The Seattle Department of Transportation

Madison Corridor Bus Rapid Transit (BRT) Study November Outreach Report

December 2015

Figure 2 Comments on Detailed Corridor Map

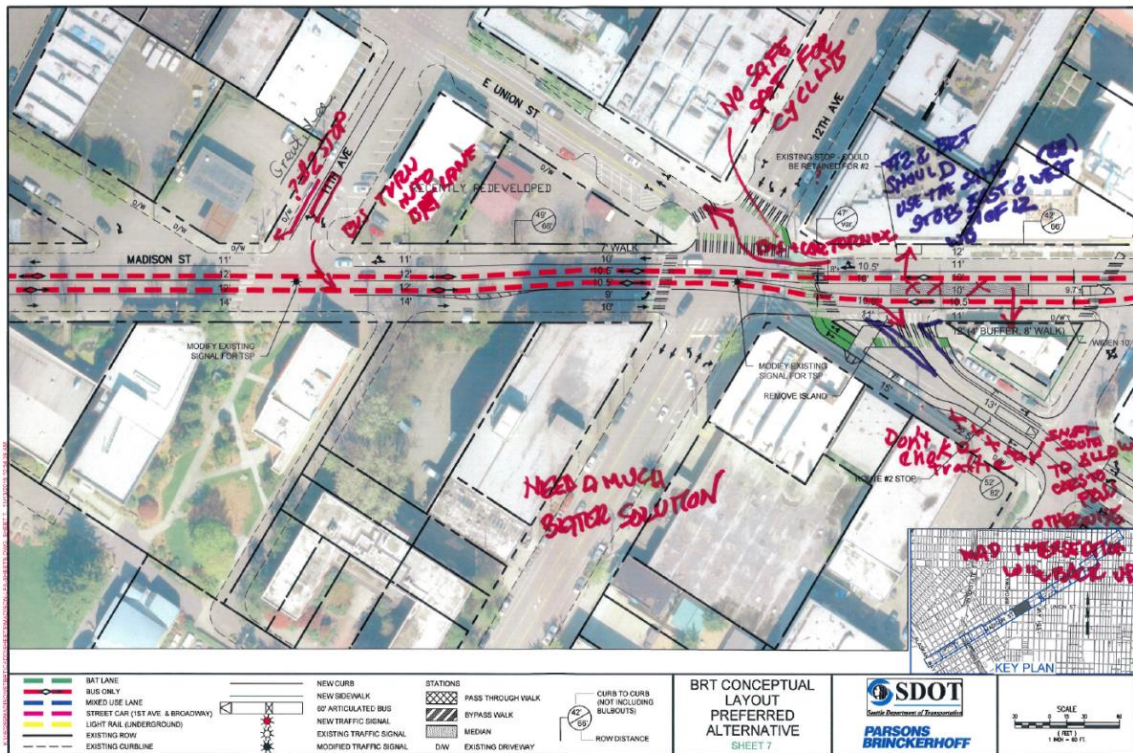
Relatively few comments were received on the detailed map set. Most comments were related to issues of placement and location of stops and connections:

- The parking lane on the north side of Spring east of 6th Ave should be converted to a left-turn lane so that BRT vehicles do not have to wait behind vehicles maneuvering in and out of parking spaces;
- The stop at Boylston Ave should be moved east, to be closer to Broadway;
- Route 2 and BRT should use the same bus stops at Madison and 12th Ave;
- It would not be safe for bicyclists on Madison Stat 12th Ave/Union St,
- Improved pedestrian crossings are needed on 24th Ave at Madison St;
- John St should be restricted to eastbound-only east of Madison St; and
- The westbound stop at 27th Ave should be moved closer to MLK Jr. Way to be closer to businesses.
